Subject: Dead Laundry Objection

The following paragraphs detail my objection to the Dead Laundry project on the Nez Perce – Clearwater National Forests. I have submitted previous comments regarding these concerns and those concerns have largely been ignored by the Nez Perce Clearwater National Forest.

Figure 1- Forest Plan Appendix K Waterheds

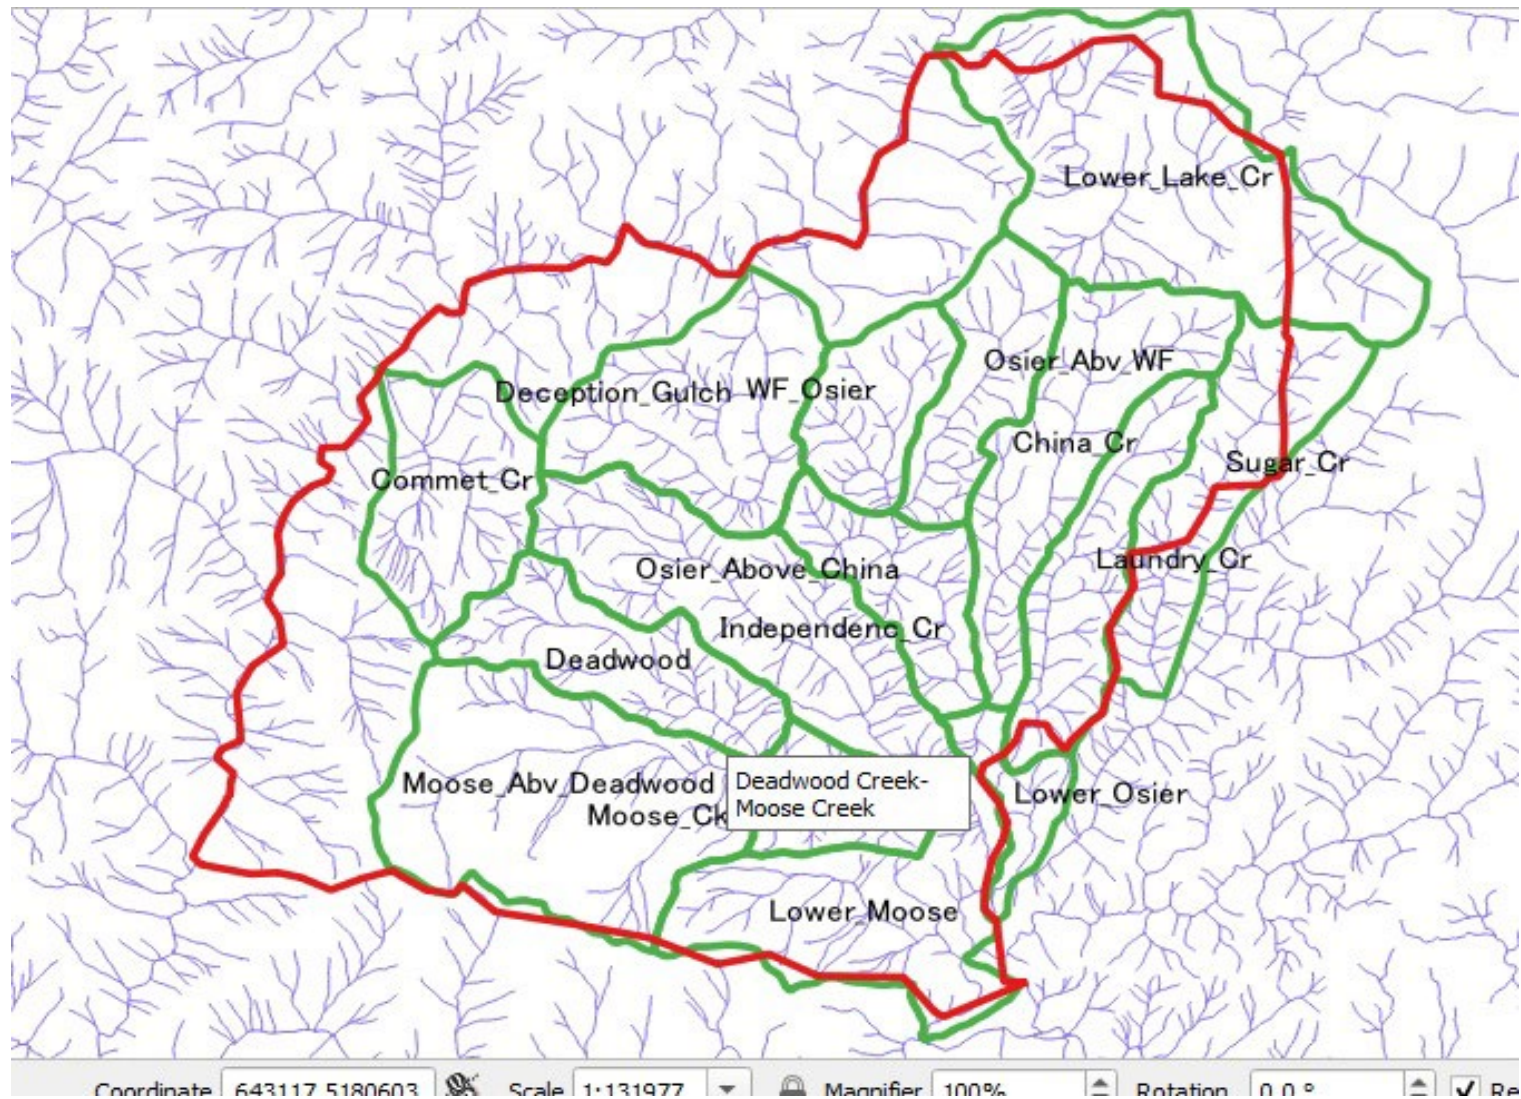
I noted in my scoping comments that Forest Service should be using Forest Plan drainages for their analysis of watershed conditions. Using the larger HUC 12 watersheds as the Nez Perce - Clearwater Forest has done for most of their analysis will tend to dilute the impact of proposed activities on drainages identified in the Forest Plan.

The project area contains 15 watersheds (Figure 1 and Table 1) identified in the Forest Plan. In a 1997 report, Jones and Murphy suggested that eight project area fisheries streams were not meeting Forest Objectives for cobble embeddedness (Table 1). The Nez Perce – Clearwater NF has not updated that report in the last 25-years, but did sample five streams in 2019 as part of this project. Resampling confirmed that conditions in Osier, China Creek and Moose Creek above Deadwood Creek have not changed significantly. China and Osier still remain well below objectives for cobble embeddedness, and Moose Creek above Deadwood Creek remains with relatively low levels of cobble embeddedness (Table 1). Moose Creek above Deadwood Creek is an unroaded drainage, as are most other streams in the project area meeting Forest Plan standards for cobble embeddedness.

The watershed analysis needs to be redone to display potential impacts to the drainages listed in Appendix K of the Forest Plan. Realistic expectations need to be made regarding the likelihood of mass wasting events and some level of risk assessment needs to be made regarding the implementation of best management practices. Time and time again the Forest Service has projected that their activities will produce no measurable amounts of sediment and that best management practices will protect water quality only to have those practices not live up to expectations in actual practice. Monitoring efforts by Friends of the Clearwater and others have documented many instances where best management practices have failed to achieve Forest Service claims. Attached (Appendix A) are some photos I took on a visit to the Robo Elk project on the Palouse Ranger District. Similar photos could have been taken on most other projects on the Nez Perce – Clearwater NF.

Figure 2 – HUC-12 drainages used in both the Watershed and Fisher Analysis

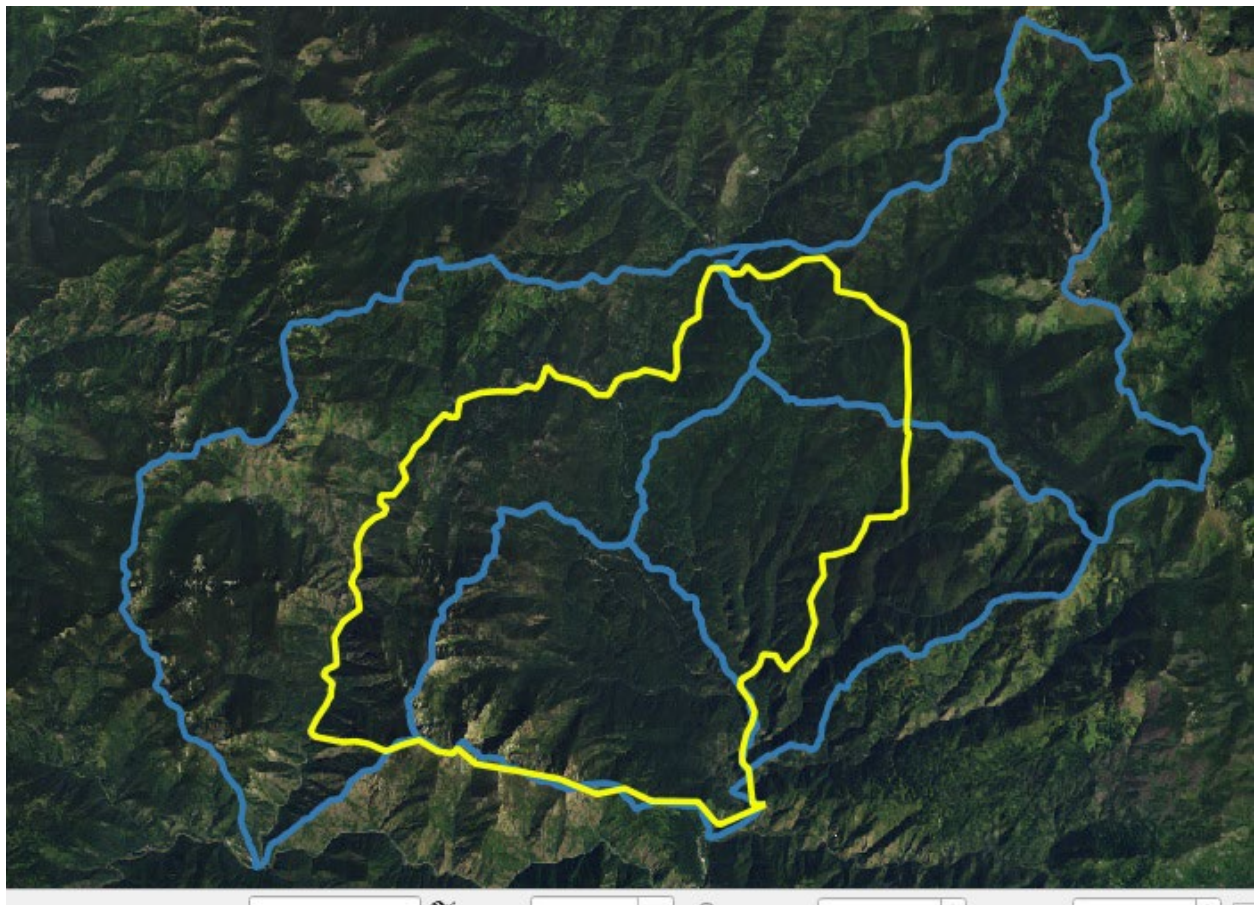
For example, in the Elizabeth - North Fork Clearwater HUC-12 watershed there 38,556-acres and most of that acreage is located outside of the project area and currently roadless (Figure 2). Within the project area, there are only two small drainages with any fisheries standards (Comet Creek and Deception Gulch). All other drainages in the project area are steep face drainages that drain directly into the North Fork of the Clearwater River. No logging is planned Comet Creek or in the steep face drainages in the southern portion of the project area. Slopes are steep and rocky in these face drainages. There are two planned prescribed burns located within the southern face drainages.

All four of the HUC-12 watersheds used in the watershed report have large unroaded areas, and three of the HUC-12 watersheds contain large areas outside of the project area. The only HUC-12 watershed that occurs entirely in the project area is Deadwood/Moose and that watershed is mostly roadless (Figure 2). Harvest units in this HUC-12 drainage are generally located within or near the Independence drainage, which has had a great deal of active mining and past harvest. Independence Creek is immediately adjacent to Osier Creek where most other project activities are occurring. There are several prescribed burning units located in the roadless portion of this HUC-12 watershed, but no logging or road construction in that portion of the Deadwood/Moose HUC-12 watershed.

The Environmental Assessment utilizes the project area (40,565-acres) and four HUC-12 (Hydrologic Unit Code) drainages (Elizabeth/North Fork – 38,556-acres, Lake Creek – 22,061-acres, Osier Creek - 19,830-acres and Deadwood/Moose Creek -14,307-acres) for the analysis of fisher habitat (Figure 2). With the exception of the Deadwood/Moose Creek, the evaluation areas are much too large to properly evaluate the impact of the proposal on fisher habitat. When the analysis is done over very large areas there is a tendency to dilute the actual impacts of the proposal on individual home ranges.

The 40,565-acre project area would likely support three female fishers, but when the analysis is done over the entire project area or includes large unroaded areas within or outside of the project area (Figure 2) there is a tendency to dilute the actual impacts within the three potential home ranges that will be impacted by the proposal. For example, most of the proposed project activity is being proposed in the Osier Creek HUC 12 watershed which is listed as 19,829-acres. This rather large analysis area includes the Swamp Creek drainage (6,486-acres) which is largely unroaded and three other drainages (Osier, China and Laundry Creeks = 13,343-acres) that have been extensively roaded. Almost all of the proposed harvest units occur in Osier, China and Laundry Creeks (Figure 3). Calculations of mature forest and open habitat that are made for this larger area tend to underestimate the actual impact to fisher habitat.

Figure 3 – Approximate Location of the proposed Dead Laundry Harvest and Fuel Treatments (Forest Service GIS coverages were unavailable to me)

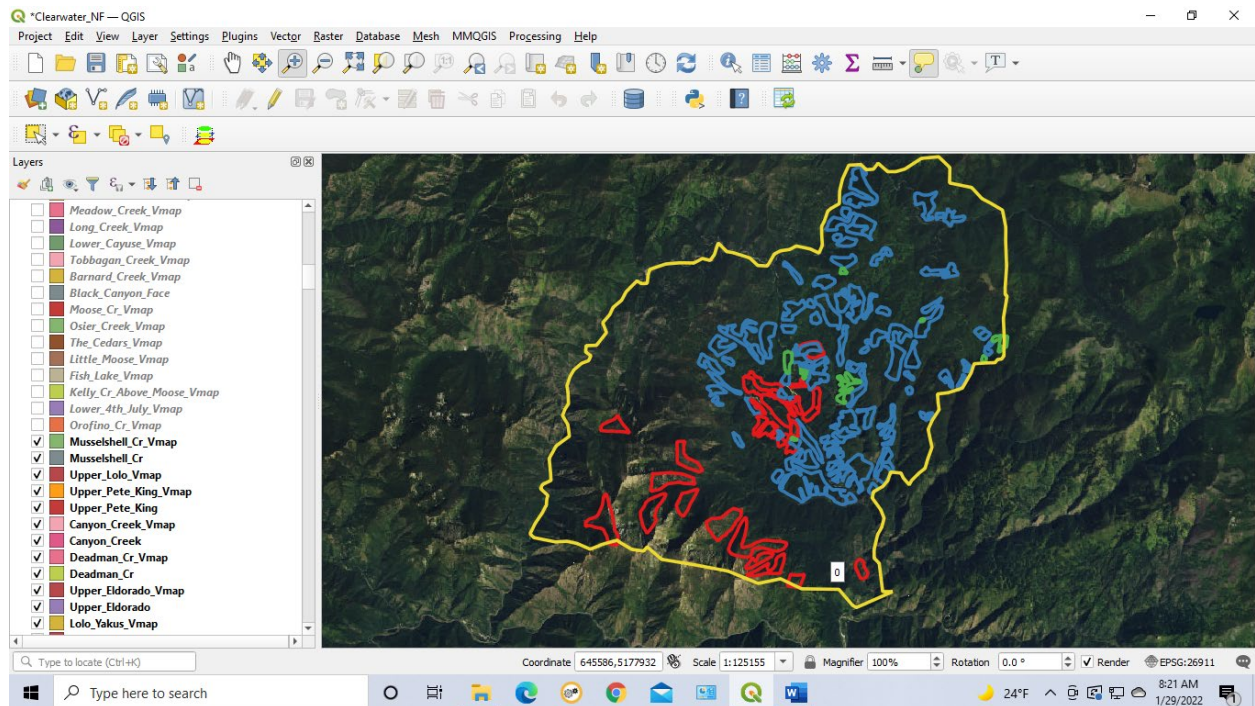
Several timber harvest units are located in the Deception Gulch watershed (2,859-acres) and the face drainages to the north near the Cedars Campground (Figure 3). These face drainages contain deeper soils and are more forested than their counterparts to the south. Sediment values are not presented for any of the watersheds identified in the Forest Plan or the face drainages to the north. All values are reported for the much larger HUC-12 watershed. Thus, most of the sediment is being produced in Deception Gulch or the face drainages to the north, but sediment production is being applied to the larger HUC-12 watershed which is mostly roadless and located outside of the project area. Road density and water yield have been calculated similarly.

Over 20% of the project area is considered unsuitable by the Forest Service and only 21% of the project area is considered mature forest. Despite the fact that Sauder and Rachlow (2014) suggest 50% of fisher home range should be maintained as mature forest, the Nez Perce - Clearwater still proposes to harvest approximately 1,300-acres of mature forest in a concentrated area (Figure 3). This activity along with treatment of over 3,150-acres of younger forest stands will create multiple openings in this same concentrated area. This activity could displace fishers to outlying locations where they will come in conflict with the existing residents. More likely, the overall habitat quality will be reduced so that the existing home ranges of one or two fishers would be eliminated. According to the Forest Service analysis 34.8% of the project area would be in openings or an unsuitable condition that likely supports more interspersed opening. Looking at just the roaded portion of the project area where harvest is concentrated (Figure 3) numbers would be much higher.
